# Submissions Report

**Infill Affordable Housing**

**59-63 Trafalgar Avenue, and 1A & 1B Valley Road, Lindfield**

**SSD-79276958**

Figure 4 – Overlaid Survey Plan on Roof Plan

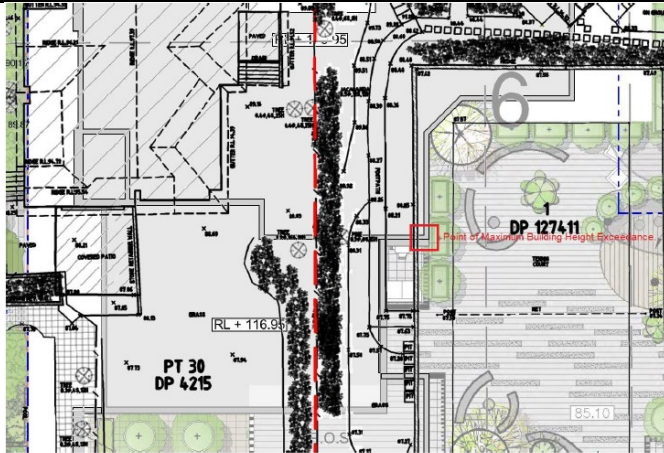
Based on Figure 2, it is observed that the largest non-compliance in building height occurs at the roof parapet of the proposal (+4470). However, the maximum building height of the proposal cannot be correctly calculated due to insufficient detail on the architectural plans provided. It is acknowledged that the 'SITE PLAN' (drawing no. DA102) contains proposed roof level RLs. However, when attempting to assess the maximum building height contravention (+4470) by overlaying the 'SITE PLAN' with the exhibited Survey Plan, EGLs directly below this point are not annotated. This can be observed in Figure 4 below:

The Revised Architectural Plans (**Appendix C**) include the following:

- Site Plan: includes roof parapet RLs
- Elevations and Section Plans: Corresponding Existing Ground Levels (EGLs)

Figure 5 – Parapet over Existing Swimming Pool Location

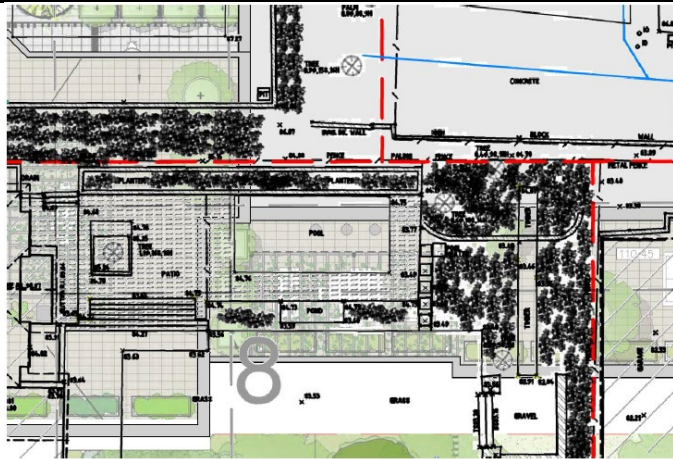
The extent of variation is not considered to be “...limited to a part of the uppermost levels”. Rather, it is considered that significant portions of the roof exceed the maximum building height. This is particularly evident on the proposal’s north-western roof, as depicted in Figure 2 above, where only a minor portion of the roof complies with the maximum building height. The Clause 4.6 also states:

The further amendments to the revised scheme have reduced the degree of variation proposed to the 28.6m height limit. The proposed variations are outlined the Revised Clause 4.6 Variation (**Appendix A**) and generally consist of roof parapet and plant (refer to **Figure** below) . :

Figure 6 – Residential Floor Space in Breach of Building Height

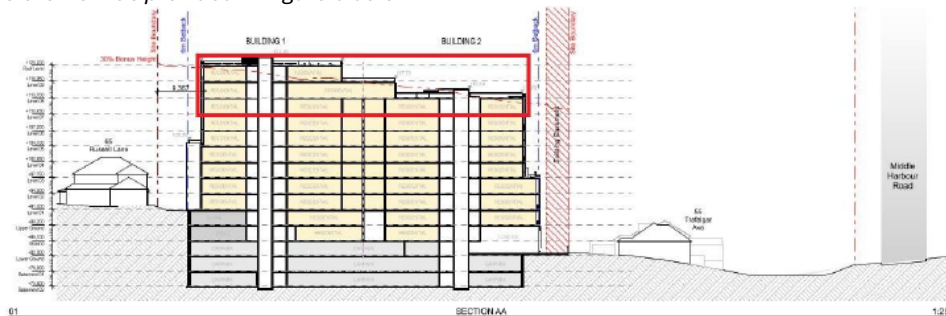
“No habitable floor space is located above the permitted height.”

However, ‘SECTION AA’ (drawing no. D310) otherwise confirms the inconsistency with this statement as provided in Figure 6 below:

Figure 8 – 'WASTE ROOM' Spot Level at RL83.89

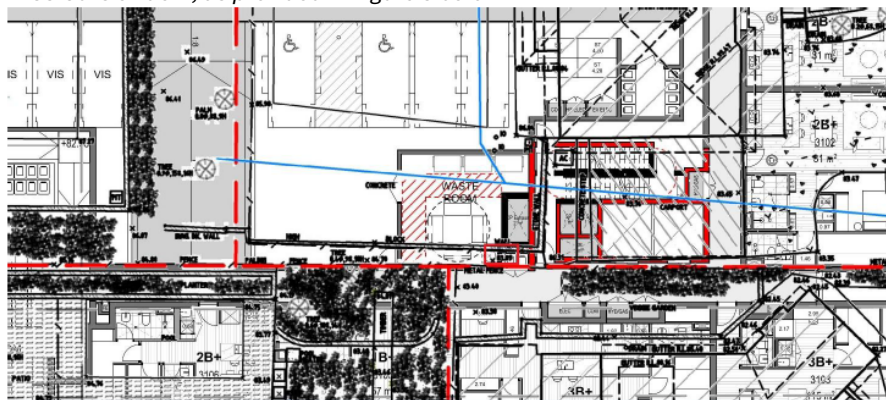
- Similarly, this applies to the 'Lower Ground Floor' 'WASTE ROOM' where a spot level at RL83.89 is evident, as provided in Figure 8 below:

- Therefore, both rooms cannot be considered 'basement', as defined, and should form some contribution to the proposal's GFA. A repeat assessment to the floor above (i.e., 'Ground Floor') also identifies that the 'STORE' room adjacent to Trafalgar Avenue is also not wholly 'basement' and should also contribute additional GFA to the proposal.
